BULLETIN NO. 091908

PRODUCT: 90 Series Boilers

TITLE: IGNITER CHANGE – PRODUCT IMPROVEMENT

PHOTO 2
p/n 550002068

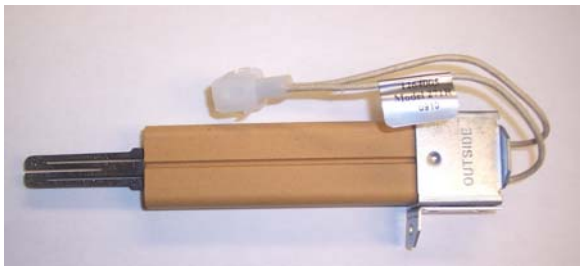
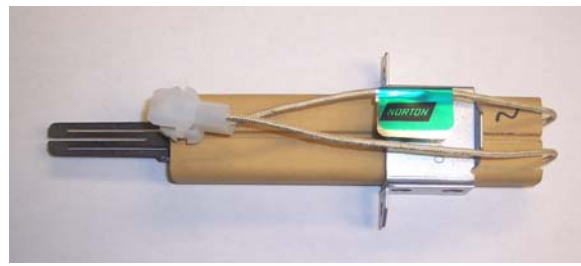
The igniter for the 90 series boilers has been redesigned to provide improved life expectancy. The change involved relocation of the mounting bracket thereby reducing the insertion depth. This allows the igniter to operate at lower temperatures while achieving the same flame signal. The bracket is offset from the end of the igniter by 1". Photo 1 depicts the original style igniter. Photo 2 is the newly redesigned igniter. The new igniter is a direct replacement and no modification or re-wiring is needed. The part number for the new igniter is 550002068.
